City of Portland, Maine - Building or Use Permit Application
 389 Congress Street, 04101 Tel: (207) 874-8703, Fax: (207) 874-8716

Permit No: 01-0552 Issue Date: **MAY 29 2001** CBL: 332 D020001 *21, 22*

Minor/Minor Site Review for New Detached Single Family Dwelling, All Purpose Building Permit Application

**CITY OF PORTLAND, ME
BOCA 1999 Plan Review Record
One and Two Family Dwelling**

FLOOR PLAN

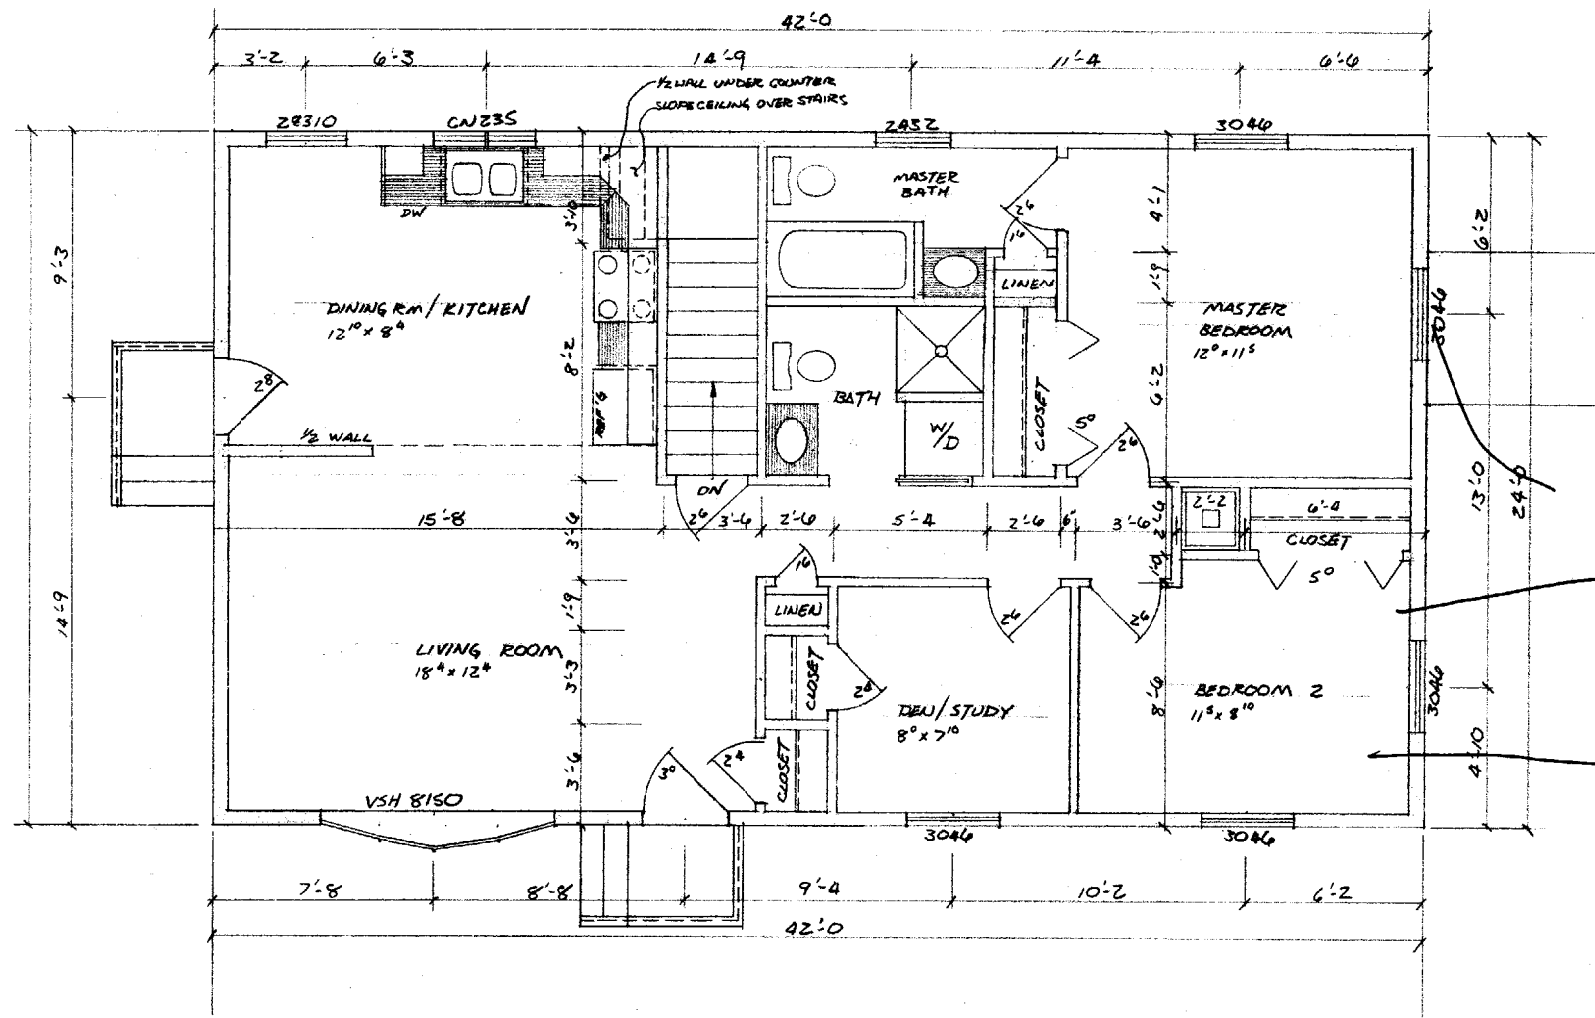
Sleeping room egress or rescue window. Sec. 1010.4

Smoke det. Sec. 920.3.2

SECTION c STAIRS

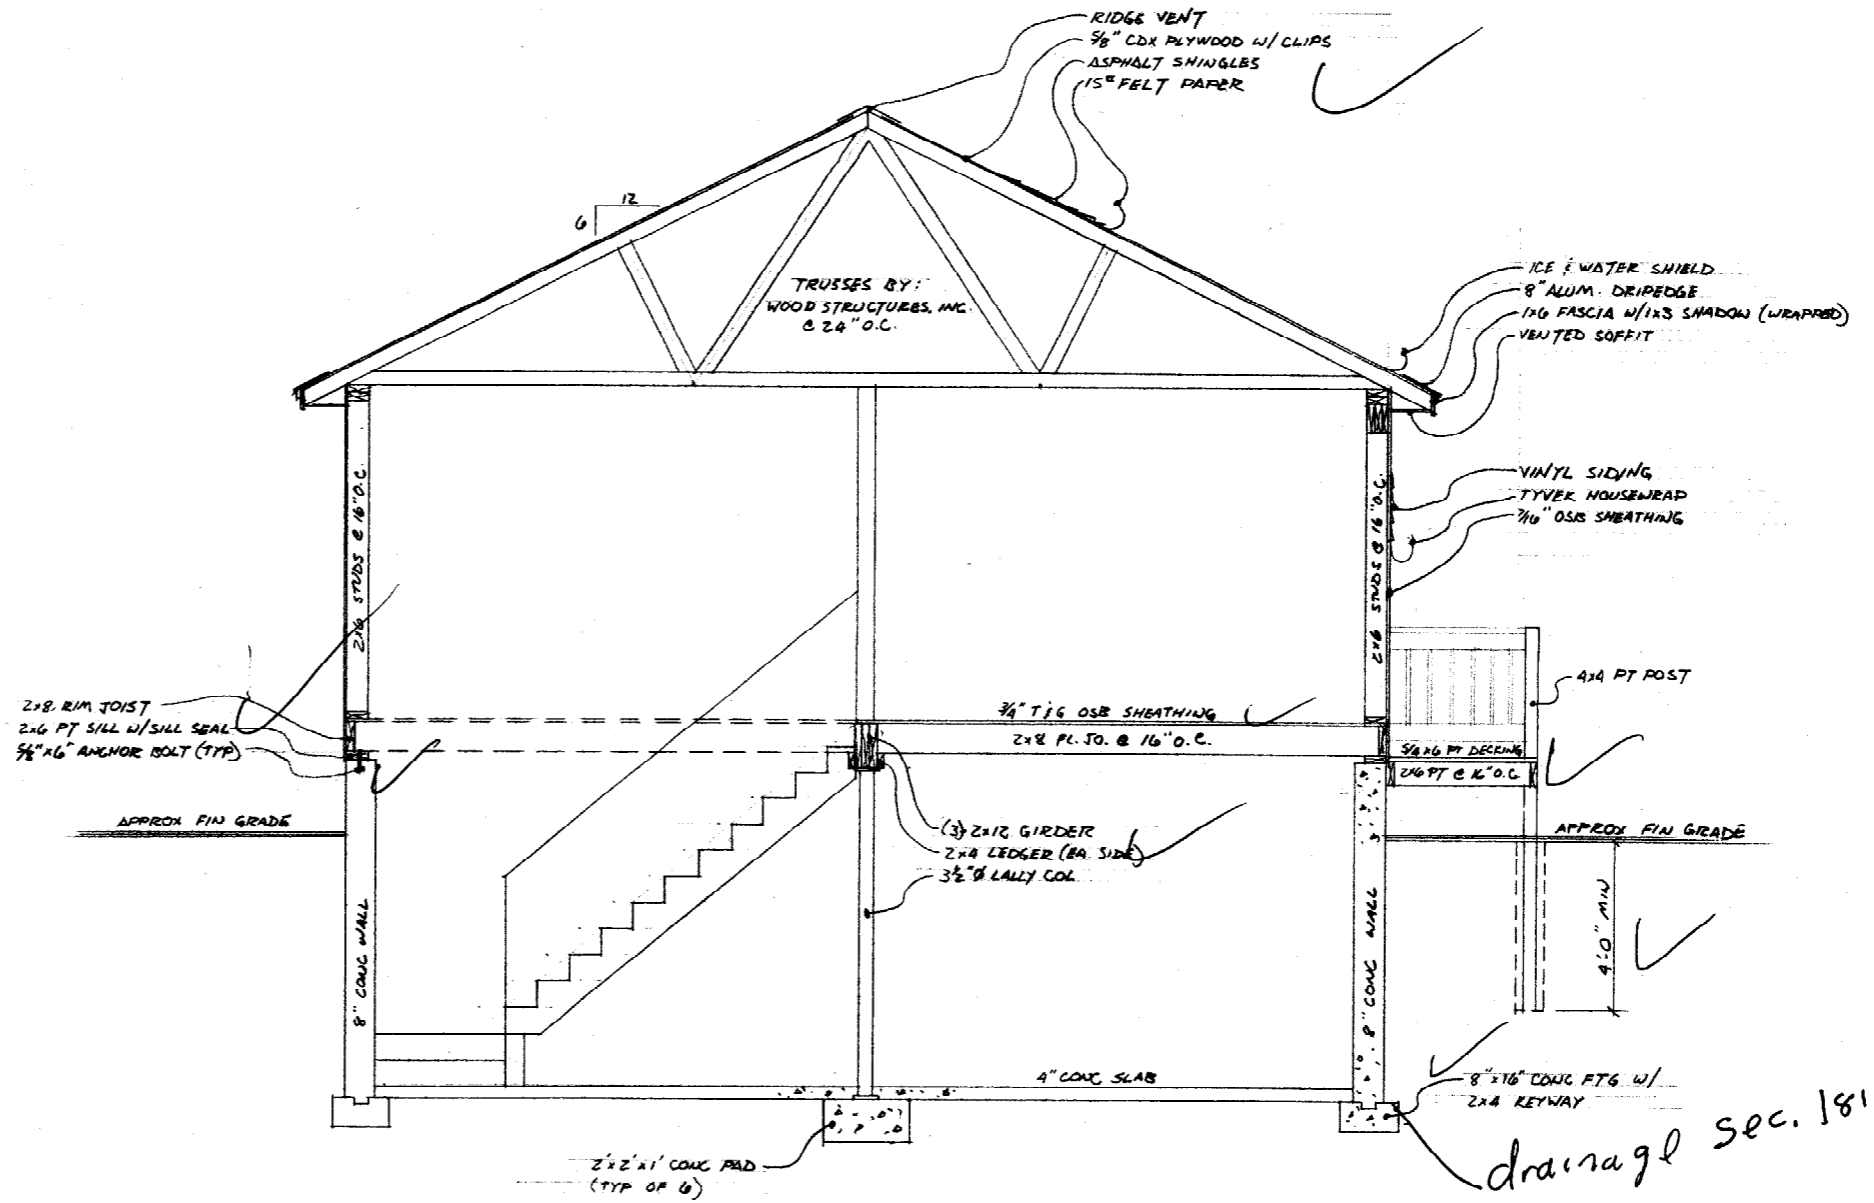
drainage sec. 1813.5.2
